CLEEVES RIVERSIDE QUARTER DEVELOPMENT

**Childcare Assessment**

| Project:     | 20035 Cleeves Riverside Project/SIA  |

This report responds to a request for further information issued by An Coimisiún Pleanála (ACP) with respect to Childcare Provision. Clarification was sought with respect to two specific areas including:

**Figure 1.0** Map of Childcare Facilities in the Area

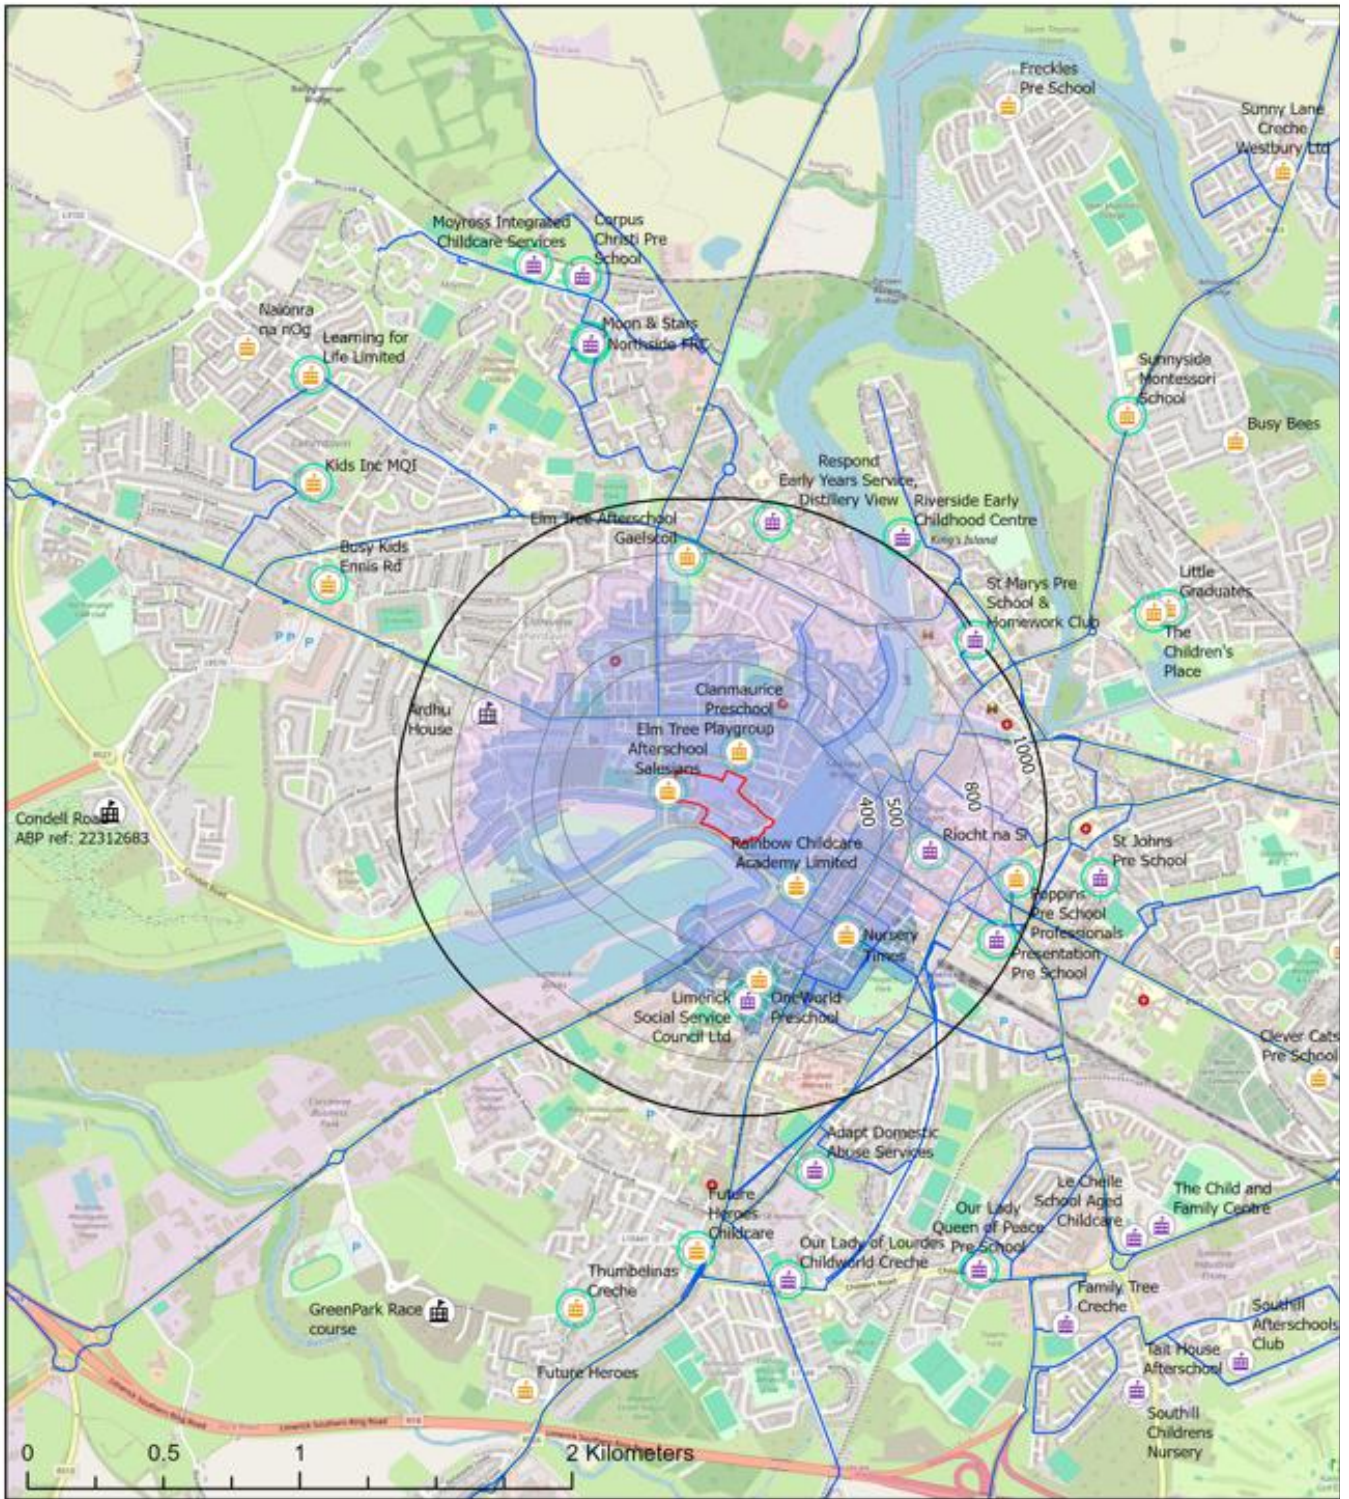
*Item 2 - The applicant is also required to clarify the number of such facilities in the area including a map highlighting the locations of childcare facilities within the vicinity of the subject site and demonstrate the need for an additional facility at that location. In addition, the applicant shall engage with Limerick Childcare Committee and submit documentation to demonstrate requirement for a childcare facility at this location.*

A total of 26 no. operational childcare facilities were identified within an approximate 2km radius of the subject site (equivalent to approx. 15 -minutes' drive time), as shown in Figure 2.0. The facilities identified with a green circle are those childcare facilities within a 2km radius of the site. Specifically, there are 11 no. childcare facilities within a 15minute walking distance (purple shaded area in Figure 2.0) radius of the subject site. This number increased to 14 no. facilities if one considers the 1km catchment area (black circle outline).

**Table 4.0** Childcare Spaces within 2km of Site (identified with green circle on map)

In addition to the above assessment, which indicates no capacity in childcare provision within 2km of the site, the Limerick Childcare Committee also confirms the position as detailed in correspondence received and detailed in Appendix 1.0 of this report.
